HISTORIC PRESERVATION COMMISSION

Historic Area Work Permit #588053—side porch enclosure

MONTGOMERY COUNTY HISTORIC PRESERVATION COMMISSION STAFF REPORT

PROPOSAL: Enclosure of side porch

Existing East Elevation
16 Magnolia Parkway

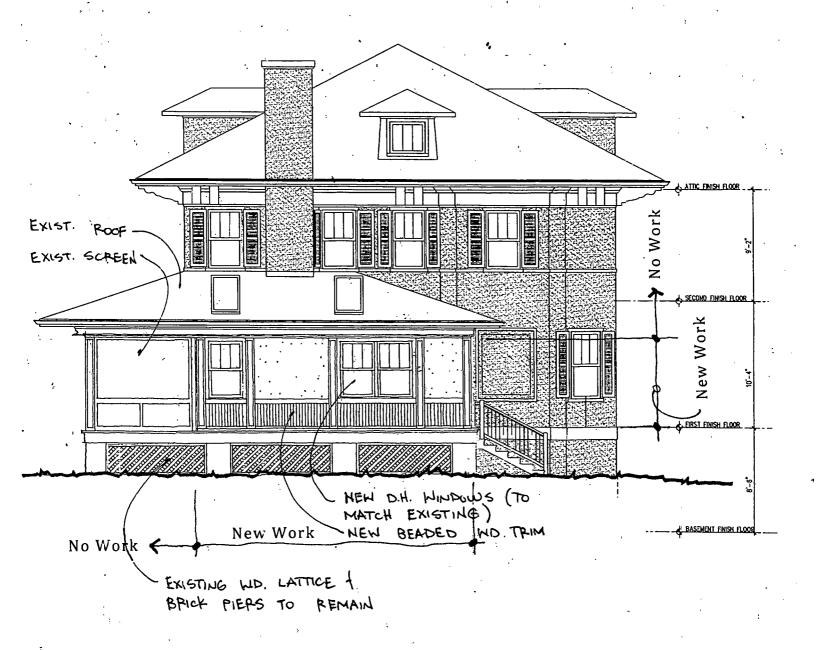
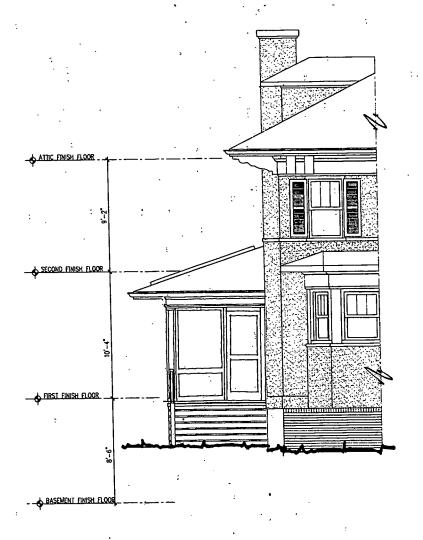
I know the applicants want a mudroom but is there any chance the panel width could be reduced so that the enclosed porch has more transparency and less solid so as to better recall the original porch? If so, please send me a revised right side elevation before Wednesday so I can forward it to the Commission.

You have accurately described the architectural challenge in converting this screened porch to an enclosed Mud Room, striking a balance between the function of the newroom and the aesthetic issues with its historic origin. Of course, the Owner would like to maximize storage potential along this exterior wall (more solid) and I realized that the HPC would probably like to maximize the original "porch" feel (more transparency). In finding this balance, I researched the parameters for the HPC review of this project (found in the Chevy Chase Village "Historic Preservation Policy Guidelines") to help me out.

As you repeat in your Staff Report, this project is to be reviewed with "Moderate Scrutiny". I followed this principle to help me design the submitted balance between solidity and transparency. In keeping the primary (historic) design elements (roof, soffit, entablature, porch floor, porch foundation) I allowed the enclosure to express elements of its porch origins while expressing its new use as an interior room.

Although the Owner would absolutely like a bit more solidity, I have assured the Owner that this submission represents my best effort at a properly balanced, appropriately compatible design which meets the principles put forth by the Village and the review parameters of the HPC.
